Detailed Site Plan Salubria Center

DSP-23015

STAFF REPORT

SUBJECT: Detailed Site Plan DSP-23015
Type 2 Tree Conservation Plan TCP2-015-12-03
Salubria Center

Figure 1: Detailed Site Plan

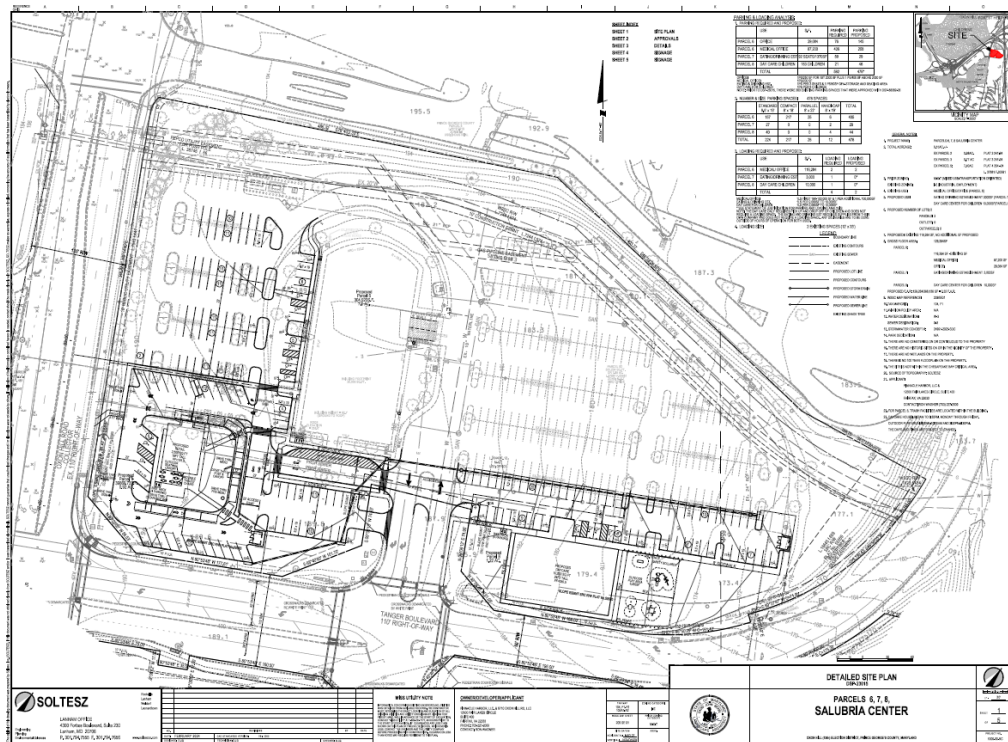
- 1. Prior to certification, the detailed site plan shall be revised, or additional information shall be provided, as follows:
 - a. Show dimensions for all sides of the proposed buildings, including the entry vestibule.
 - b. Show the setbacks from the street to the day care building.
 - c. Show day care center play area gate locations on all site plans.

- d. Show the setback from the street of the proposed freestanding sign planned for the day care center.
 - e. Provide full proposed canopy details for the proposed removal and replacement of the existing porte cochere at the entrance of the existing office building.

- f. Show the location of any proposed fire department connections (FDCs). A hydrant must be provided within 200 feet of all FDCs, to be measured as hose is laid by the fire department, in accordance with Prince George's County Subtitle 4-167.

- g. Add the following notes to Sheet 1:
 - (1) During the construction phases of this project, noise should not be allowed to adversely impact activities on the adjacent properties. Indicate intent to conform to construction activity noise control requirements, as specified in Subtitle 19 of the Prince George's County Code.

- h. Correct General Note 2 acreage to be consistent with the plans.
2. Prior to certification of the Type 2 tree conservation plan (TCP2) for this site, documents for the required woodland conservation easements shall be prepared and submitted to the Environmental Planning Section for review by the Office of Law, and submission to the Office of Land Records for recordation. The following note shall be added to the standard TCP2 notes on the plan as follows:
